ADDENDUM #1

Project: Maintenance and Repair to Columbus Readiness Center
Columbus, MS
PN: 28170312

Date Issued: August 25, 2017

ADDENDUM NO. 1

DATE	REVISION	NO
DATE: AUGUST 21, 2017		
PROJECT NO.		
JAN17012		
Sheet Number		
M1.1R1		
1 OF 1

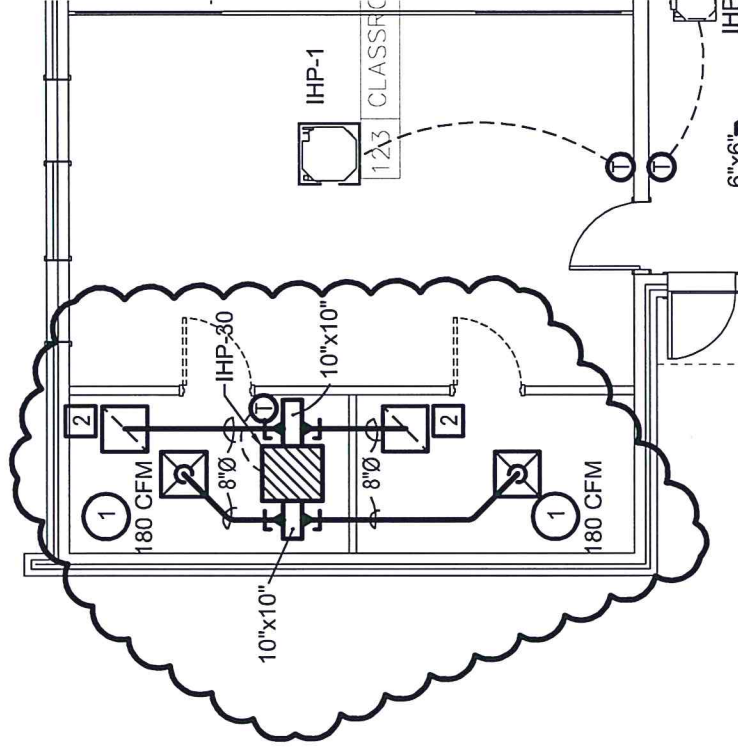
Item No. 4: Drawings, Sheet M1.1: Revise layout of 123 Classroom #2 as shown on attached Drawing M1.1R1.

M2.1R1

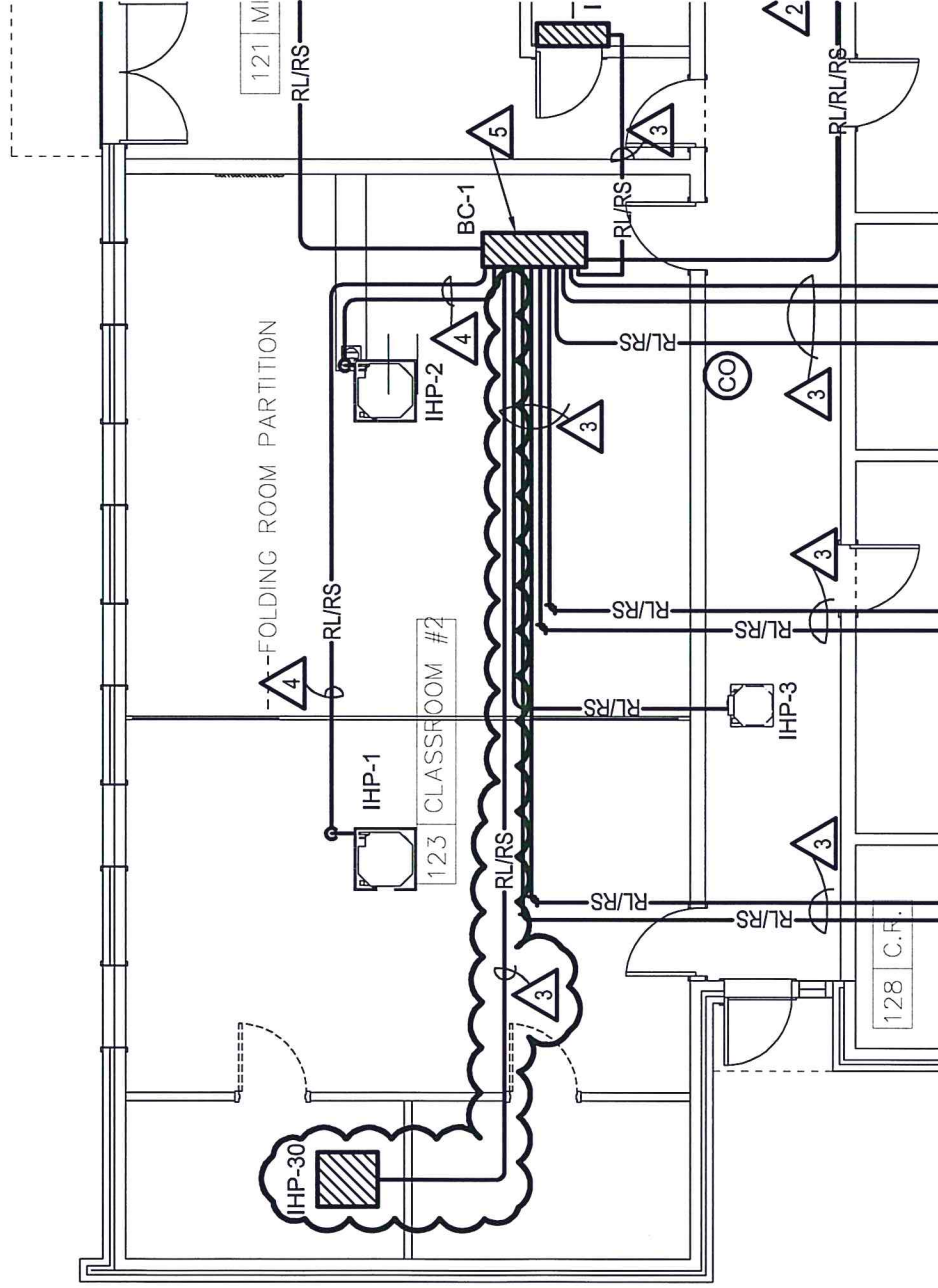
Item No. 6: Drawings, Sheet M2.1: Add IHP-30 and related refrigerant piping as shown on attached Drawing M2.1R1.

PARTIAL FLOOR PLAN - POWER

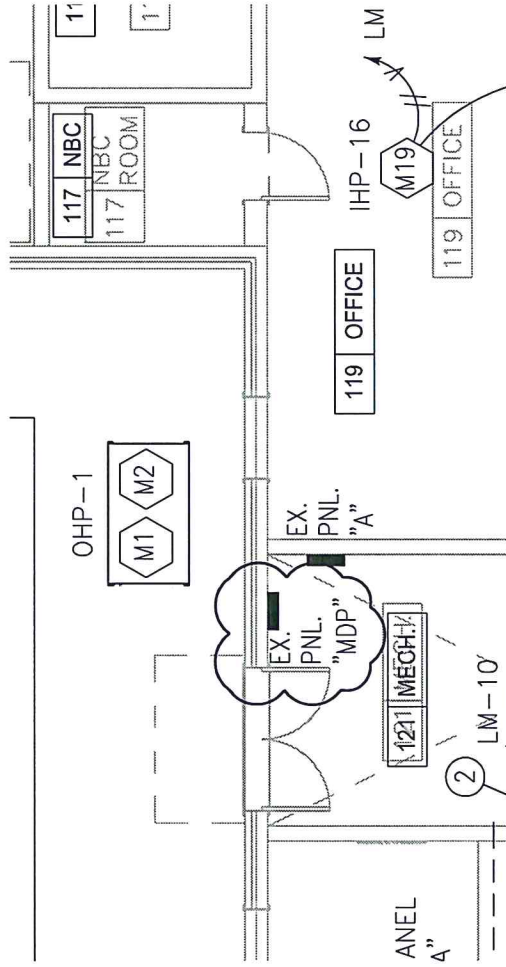
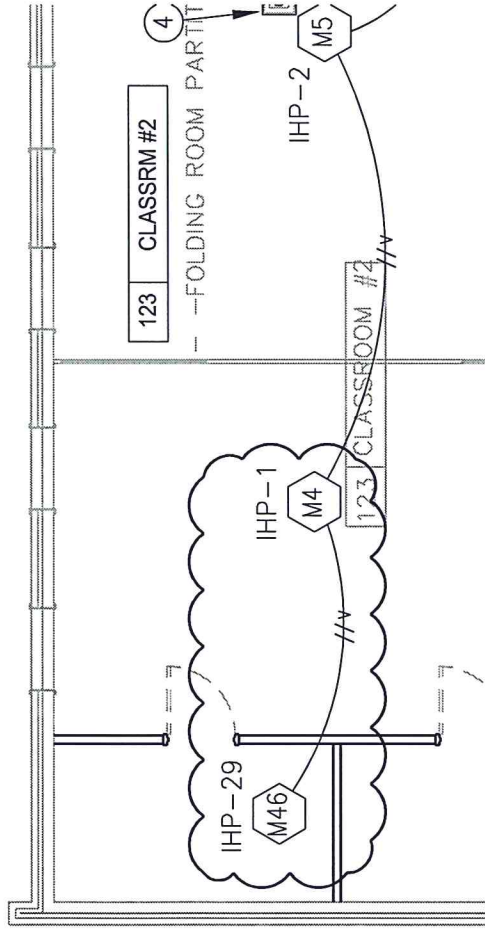
- Item No. 15: Drawings, Sheet E2.1: Revise mechanical connections in storage area and MDP location as shown on attached Drawing E2.1R1.
- Item No. 16: Drawings, Sheet E2.1: The only communications scope in this project is in room 123 classroom #2. Rough-in to be provided for the floor box as noted in keynote 4 with empty conduit bushed and provided with pull string for cabling by others. All communications outlets on site are existing to remain as-is.
